Product hierarchy no. *				Part no.	SBU	Type / Description	Customer part no.
SBU	PG	PGU	Type				
02	006	016	0000001543	See list below	Power Entry Module with Filter	5120

Filter cases for front and rear mounting have a new surface treatment process in order to product improvement.

5120					0118.2246	
creation date	created by	release date	released by	notification no.	revision	page
2014-10-23	buechlp	2015-01-20	buechlp	26907	-	1 of 2

Screw versions front-side

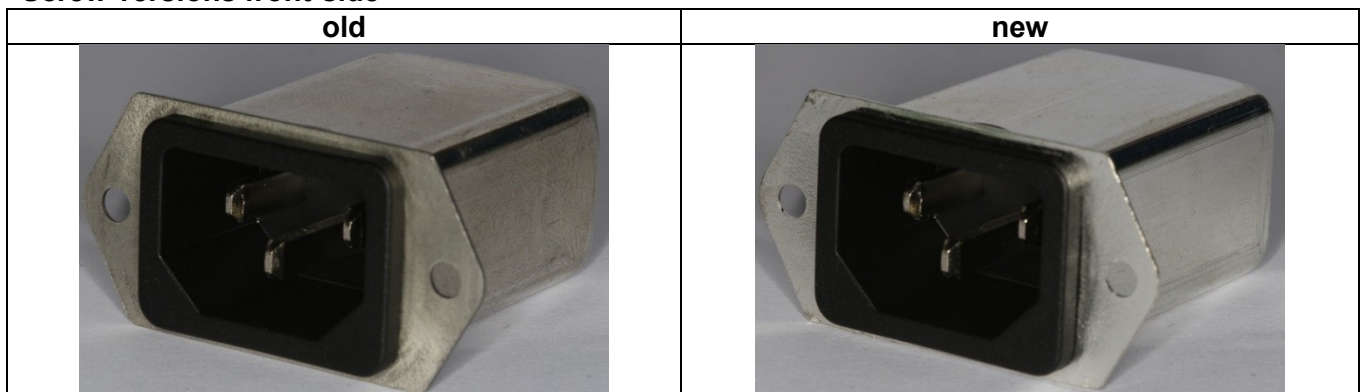
Surface treatment process of filter case has changed with no change of surface material.
